Rehabilitation of Three-Family Home 97 Williams Street January 20, 2016

PROPOSAL

STAFF RECOMMENDATION

**CITY OF HARTFORD
HISTORIC PRESERVATION COMMISSION
RESOLUTION
97 WILLIAMS STREET
HISTORIC PRESERVATION PROPOSAL**

Image of the structure from the assessor's database.

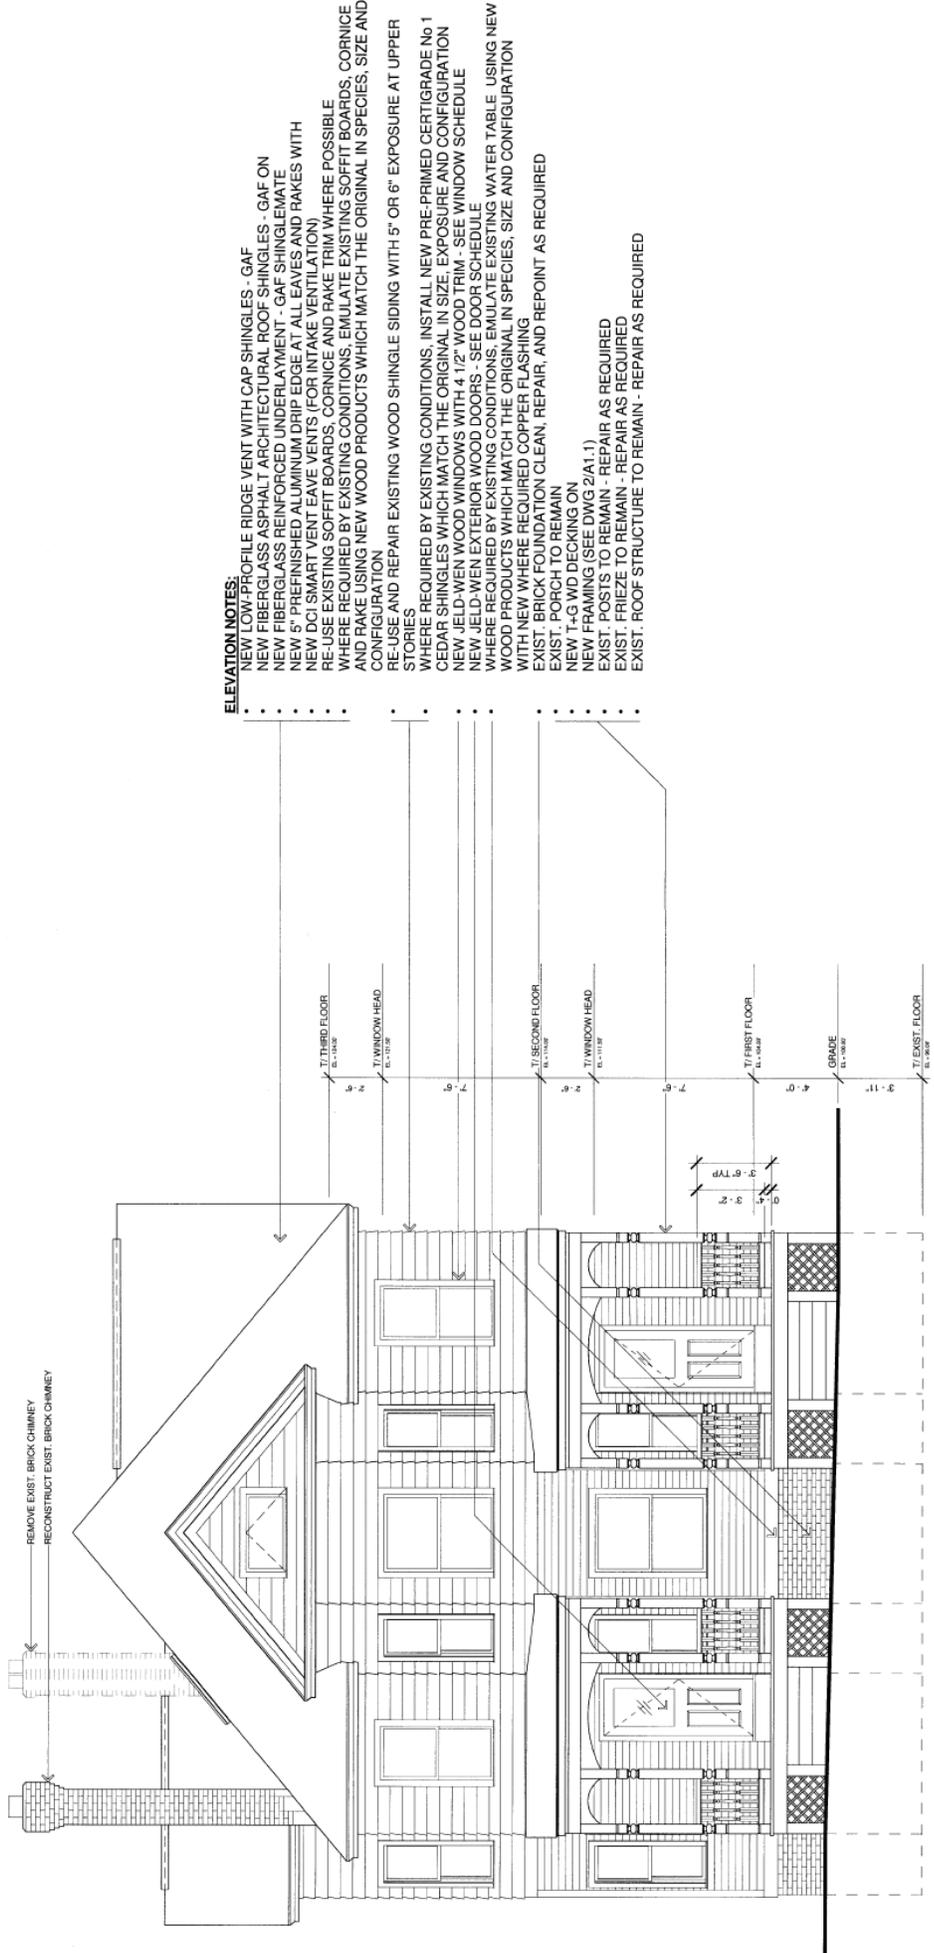
The majority of his project exemplifies good historic rehabilitation—the change from vinyl siding back to wood clapboard and shingle siding, the replacement of the remaining vinyl windows to wood windows throughout the home, the retention of the porch details, and the willingness of the applicant to take the recommendation of HPA to install turned balusters instead of square balusters as originally proposed. The addition of the dormers, the relocation of the chimney, and the addition of two skylights are new design elements. Even without the current landscaping which would make seeing them from the public right-of-way practicably impossible, the most noticeable of the proposed changes, the dormers, have been relegated to the rear of

the home where they will have the least visual impact on the home's historic character and will allow much more light into the 3rd floor unit. The skylights are also additions that have the potential to be more visible, however their low profile is unlikely to take away from the home's overall character. As indicated previously, the applicant has also reached out to HPA who has no objection to the proposed work and believes, like staff, that this project will be a great improvement in restoring the historic character of the building and eliminate a source of visual blight along an otherwise attractive stretch of historic homes.

Approval - Based on the findings and analysis in this staff report, the Planning Division recommends approval of the application.
